**City of West Linn
PRE-APPLICATION CONFERENCE MEETING
SUMMARY NOTES
February 21, 2013**

SUBJECT: Starbucks Drive Through at 19068 Willamette Drive

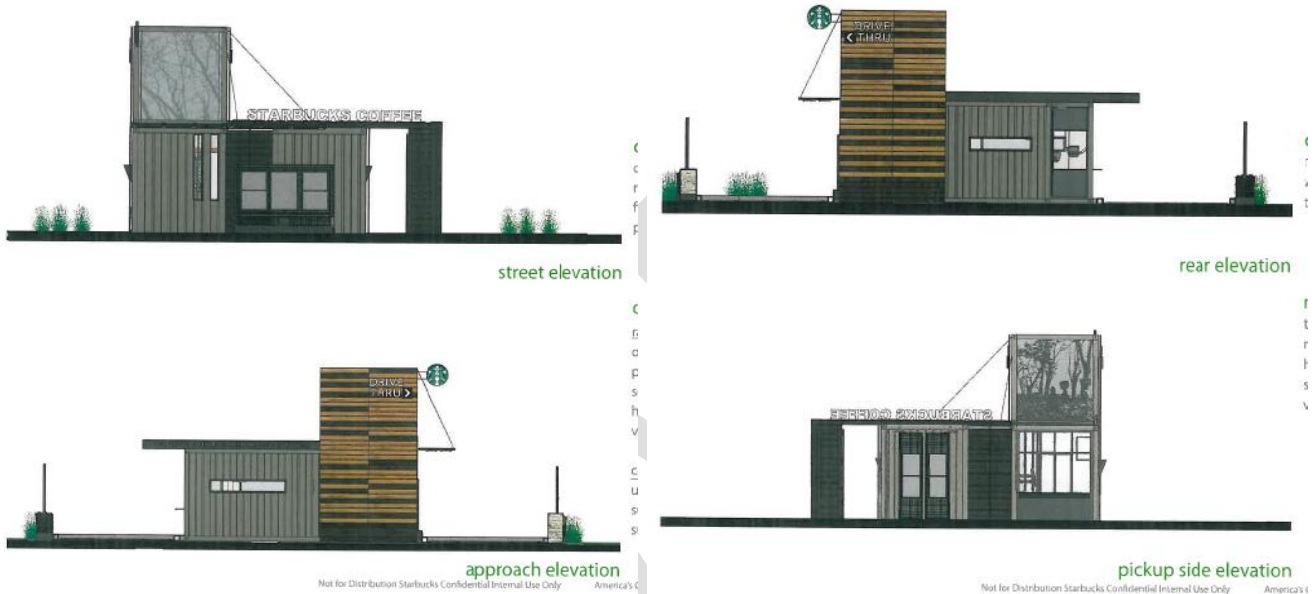
Although staff finds the use of a modular design innovative and the building design attractive, the building does not work on this site as proposed. It is set back from the street and encircled by driveways. Our design review chapter was written to address the Oregon Transportation Planning Rule requirements and the community desire to downplay the automobile and create a more attractive, human scale streetscape. Buildings are expected to be constructed at the edge of the Willamette Drive ROW. Design review does not permit drive through aisles between the business and the public ROW. (The Willamette Village was approved in 2006 based on a site plan that showed a building on this site with no setback. If that assurance had not been provided, the 2006 application would have been recommended for a denial.)

There is also a transparency requirement that 60 percent of the front elevation and 30 percent of side elevations visible from the ROW comprise windows at the pedestrian level. The specific code sections that argue against this design are 55.100(B)(6)(b)(e)(f)(i) and 55.100(B)(7)(a)(c)(f)(h). Comprehensive Plan goals and policies also would not support the design. Any design that diverges from the required standards listed above will require a Class II Variance from each of the eight standards.

As stated earlier, the choice of reclaimed lumber as a building material is an attractive idea, as is the modular design. The concern is that the architecture of the building, as seen from Willamette Drive at walking pace, will be akin to a blank wall: a dead space. (We have enough of that architecture already and want to move forward to an improved state.) Staff also notes that the proposed design reserves more attractive materials for the drive through approach and rear elevations which really communicates the indifference to the streetscape and non-customers.

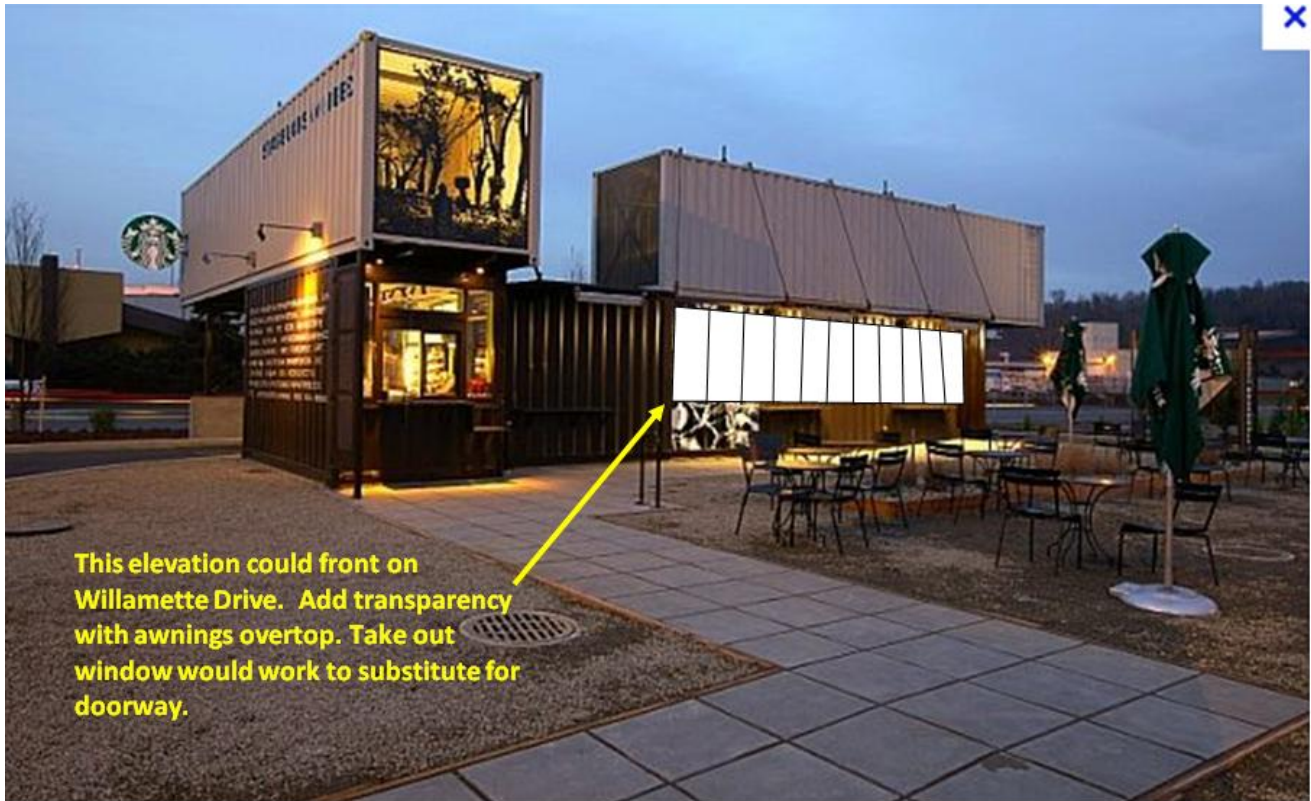
Since there is no inside service planned, no public access is shown. This runs afoul of the requirement for access/doorways on the front elevation. Providing a take-out window facing Willamette Drive is an option (see example in photo below); however a variance would still be required. There is still the expectation of an eight-foot wide continuous overhang protecting pedestrians on Willamette Drive. Overhangs need eight feet vertical clearance.

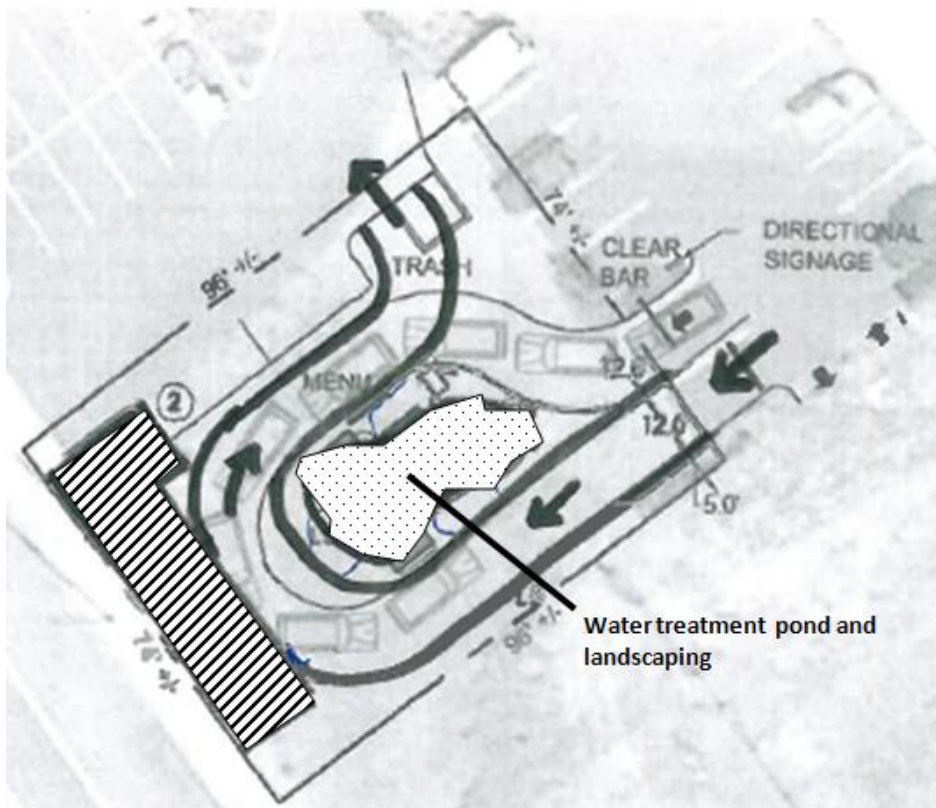
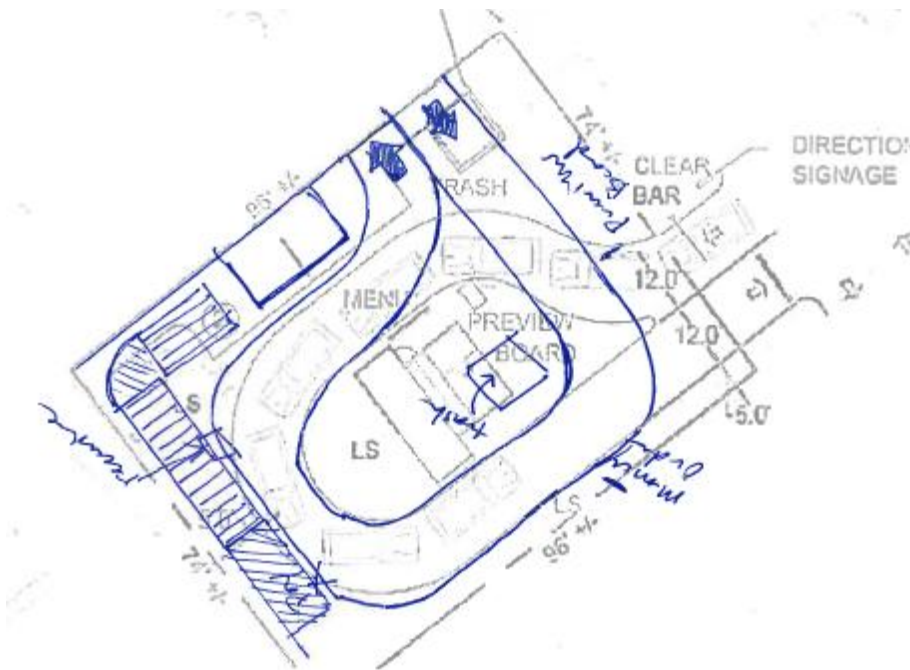
The site plan can be rearranged to meet the CDC by putting the building next to Willamette Drive and keeping the circulation behind it. Here are two options:
